APPLICATION FOR PERMIT TO DRILL OR REENTER

| 3a. Address 3 Waterway Square, St 110 The Woodlands, TX, 77380 | | 8. Lease Name and Well No. Uber East SWD #1 |

Uber East #1 APD

Uber East SWD #1 Drilling Plan

3 Rams
McVay 11" or 13 5/8" X 10-M BOP (2 Rams and Rotating Head) & Closed Loop System Equipment Schematic Diagram C

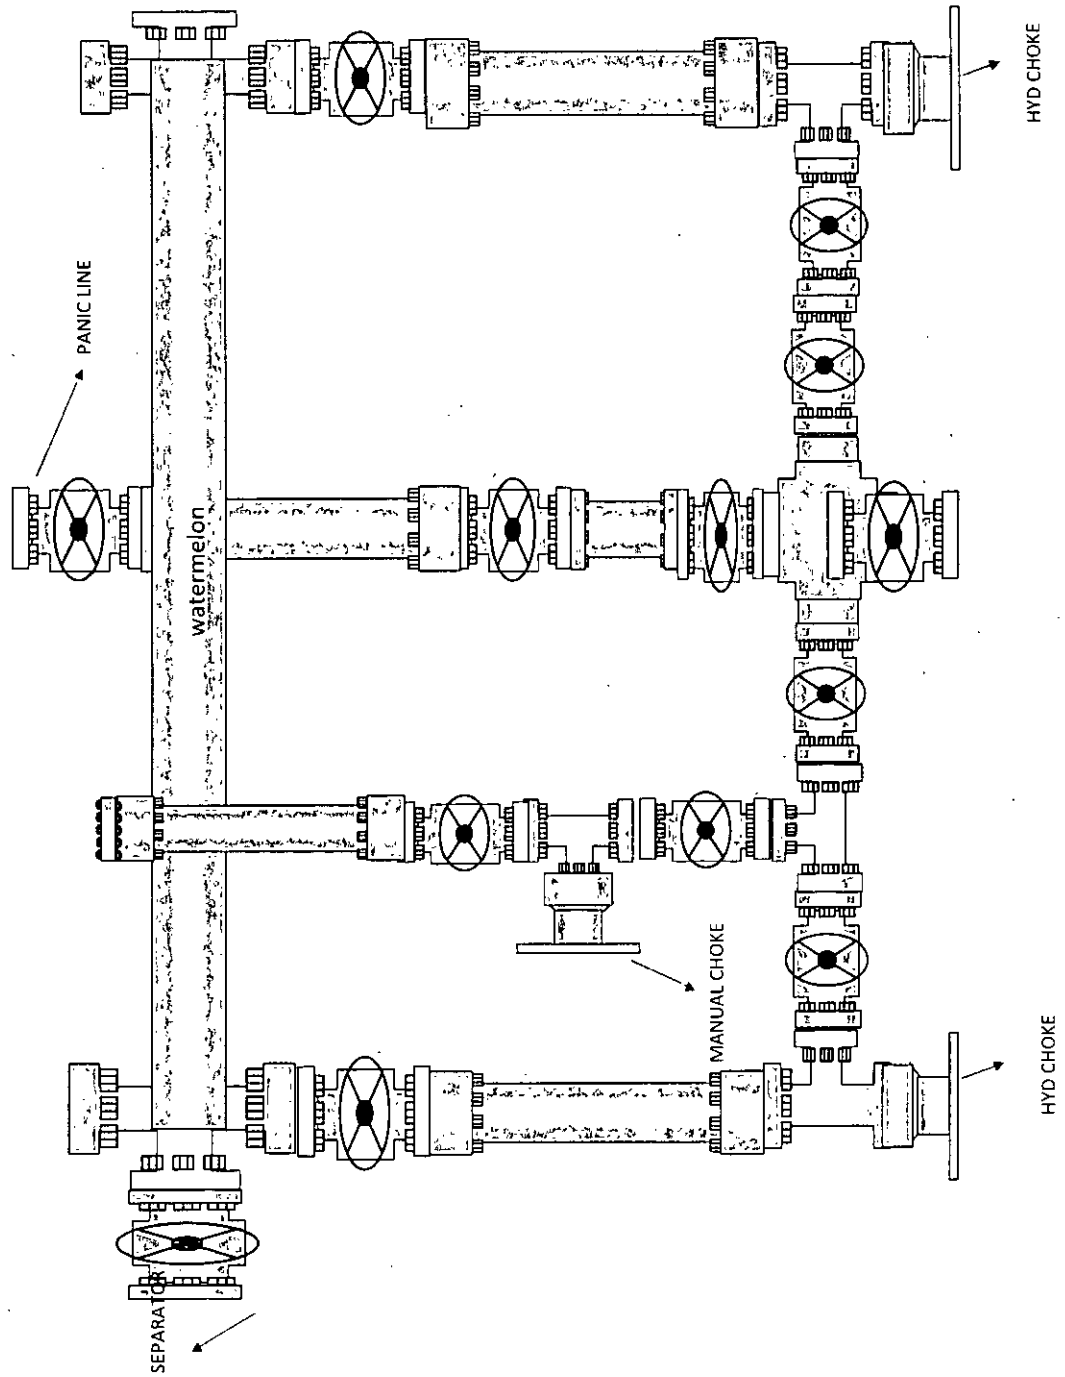
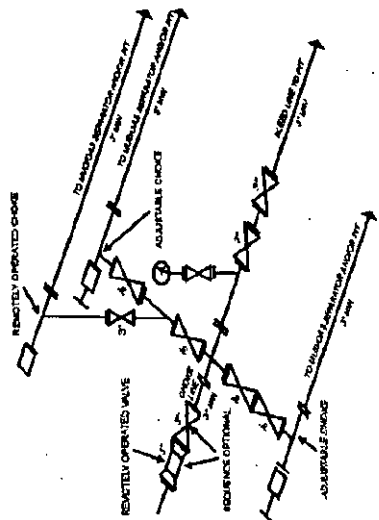
A 10M 13-5/8" BOP system (Double Ram and Annular preventer) and 2 power chokes installed on manifold and 1 manual choke per BLM Onshore Order 2, will be installed and tested prior to drilling out the surface casing shoe. The BOP system used to drill the intermediate hole will be test per BLM Onshore Oil and Gas Order 2.

A 10M 13-5/8" BOP system (Double Ram and Annular preventer) will be installed and tested prior to drilling out the intermediate casing shoe. The BOP system used to drill the production hole will be test per BLM Onshore Oil and Gas Order 2.

The pipe rams will be operated and checked each 24 hour period and each time the drill pipe is out of the hole. These tests will be logged in the daily driller's log. A 2" kill line and 3" choke line will be incorporated into the drilling spool below the ram BOP. In addition to the rams and annular preventer, additional BOP accessories, include a Kelly cock, floor safety valve, choke lines, and choke manifold rated at 5,000 psi WP.

10,000
